**Water Right Conditions
Tracking Slip**

FILE ## G-17493

PUBLIC INTEREST REVIEW FOR GROUND WATER APPLICATIONS

SUBJECT: Application G- 17493 Supersedes review of _____
Date of Review(s)

Oregon Water Resources Department Hydrograph for State Well UNIO 1536, State Observation Well # 871

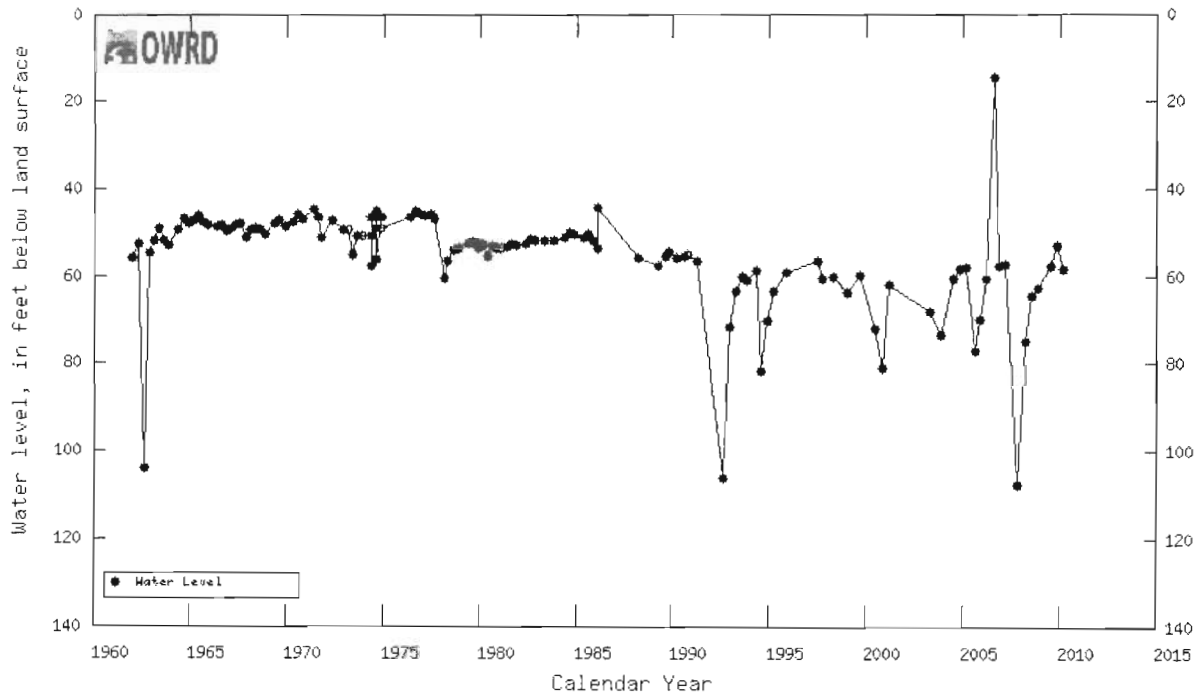
B3. **Ground water availability remarks:** There is one local well (SOW 871, UNIO 1536) with a long-term water level record. Groundwater is not intensely developed for irrigation in the area, but the proposed well may cause some interference with the City of North Powder's deep wells.
